SAFETY RECALL

SR23-43

SUBJECT: PREVOST DRIVER ASSIST – VERIFICATION
OF ACB RADAR SENSOR FRONT BUMPER
TRIM

Figure 1: VEHICLE EQUIPPED WITH ACB RADAR SENSOR

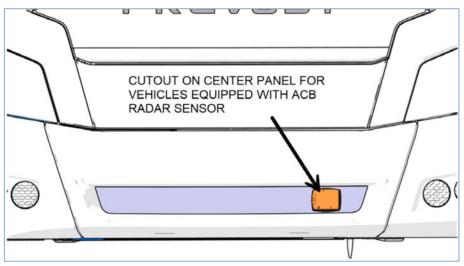
1. Vehicles equipped with the ACB radar sensor should have a cutout on the front bumper trim as seen on the image below.

Figure 2: VEHICLE EQUIPPED WITH ACB RADAR SENSOR

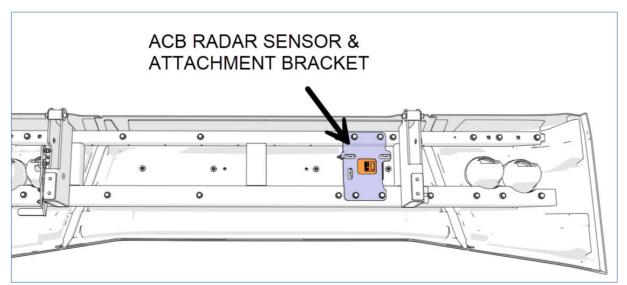
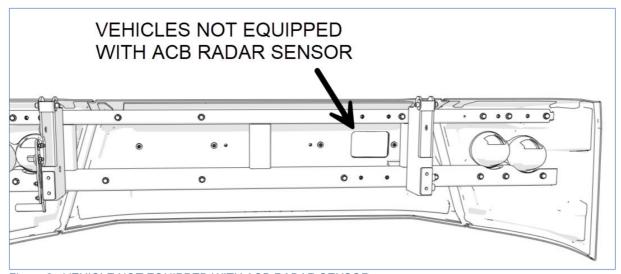
2. Open the reclining bumper. Confirm your vehicle is equipped with the ACB radar sensor.

- 3. If the front bumper trim installed on your vehicle **is** the appropriate one, no further steps are required. This completes the bulletin.
- 4. If the front bumper trim installed on your vehicle **is not** the appropriate one, perform PART 2 FRONT BUMPER TRIM REPLACEMENT.

Figure 4

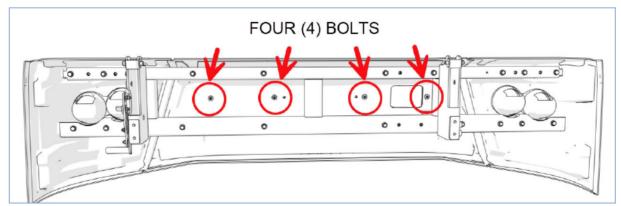
2. Remove the existing bumper trim. To do so, using a 10 mm hex socket, unscrew the four (4) bolts identified on the following image. Keep bolts and washers for reinstallation. Return incorrect bumper trim to Prevost.

3. Install the new bumper trim similarly.
